Airworthiness Directive

AD No.: 2021-0042

ATA – Hot Air Balloons – Burner Assembly and Hanger – Inspection / Modification

Service Bulletin 28

Fig 3. Burner Serial Number (296) & Part Number (CB8720) engraved on the hanger

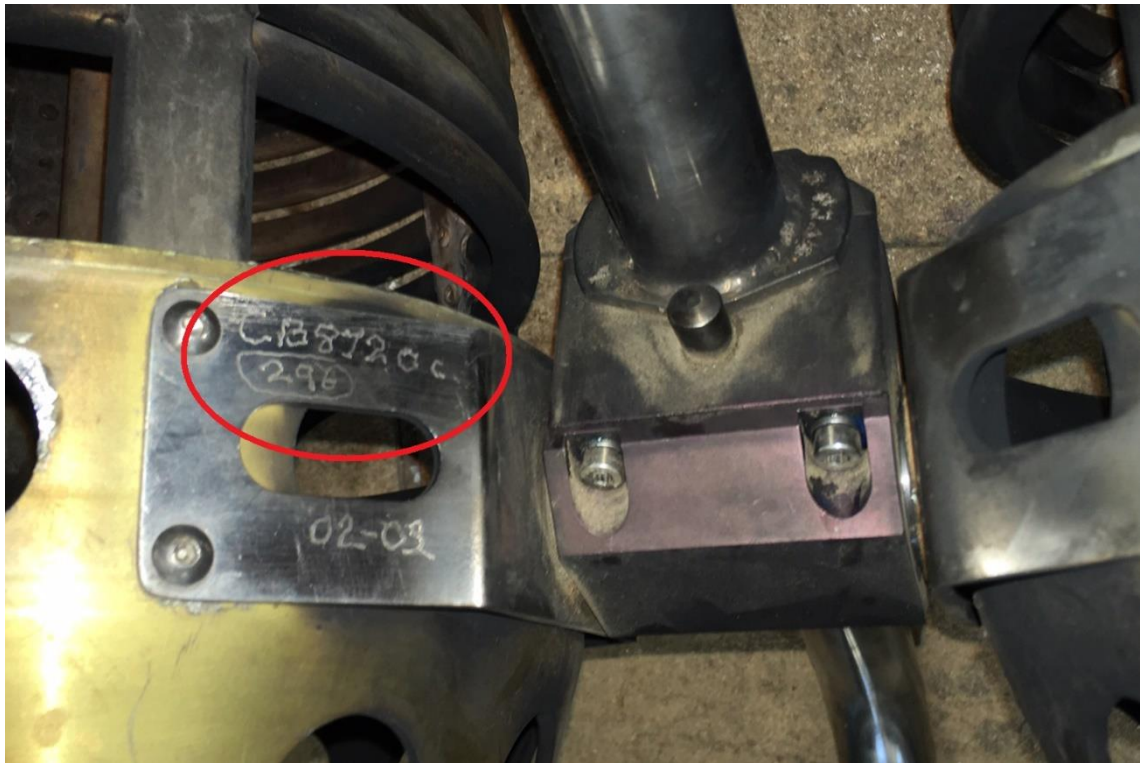
- 2.1.1 The affected hangers were fitted to double burners with serial numbers 320 or lower. The burner serial number is hand engraved onto one of the hanger end plates. Should the burner serial number be unreadable or missing Cameron Balloons can identify the burner from the manifold block serial numbers (machine engraved onto the upper surface of the burner manifold block).

Fig 4. View of Hanger Assembly.

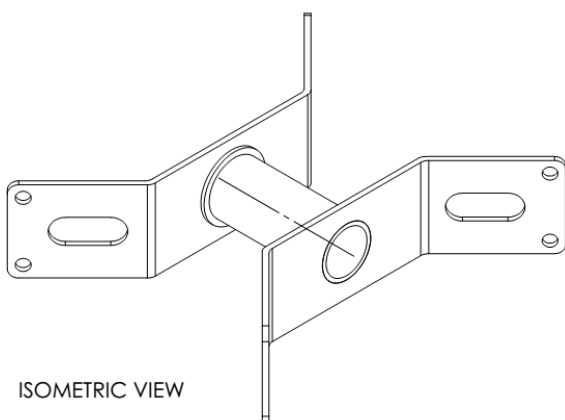
2.1.2 Affected hangers (Issues A through C) have either no machine engraving or have “Cameron Balloons Limited” machine engraved in the upper right-hand corner of the end plate. Non-affected hangers (Issue D and E) have the text “Cameron Balloons Limited” machine engraved in the lower right-hand corner of the end plate.

Fig 6. View of the affected weld. Note burner coil removed for clarity.

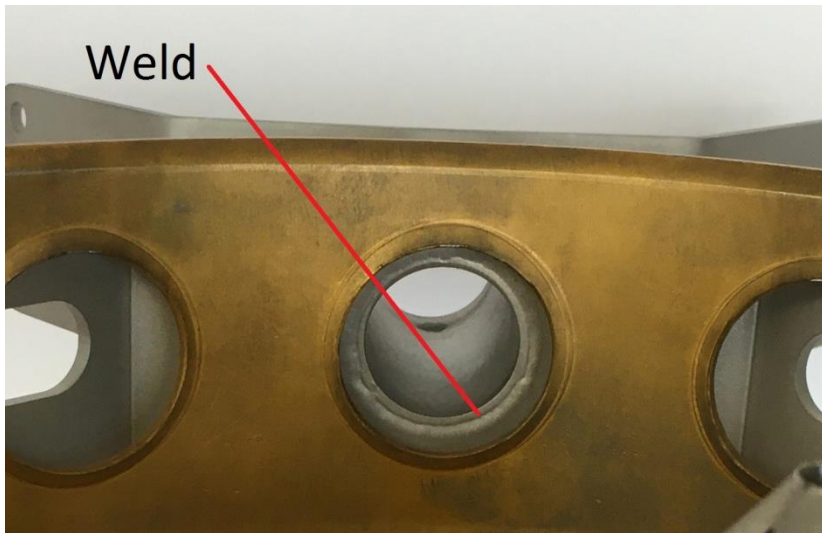
- 3.1.1 The weld in the end of the hanger can be seen through the holes in the can. A torch and a mirror may be required to give a clear view.
- 3.1.2 Remove any soot or dirt prior to inspection. WD40 or kerosene (paraffin) is the preferred cleaner; some solvent cleaners may damage the finish of the can.
- 3.1.3 Inspect the weld for any signs of cracking. Attempting to move the burner relative to the hanger may assist in making the crack visible.
- 3.1.4 If a clear view cannot be obtained or there is any doubt then the hanger must be removed from the burner. The burner is mounted to the hanger with M5 fasteners CY-0005-1004, CY-0005-1016, and CY-0005-2009. A single M3 screw secures each burner manifold block to the tubular handle.
- 3.1.5 Cracked hangers must be replaced before further flight with a new part CB-8504-0000 Issue D or later. **Cracked hangers must not be re-welded.**
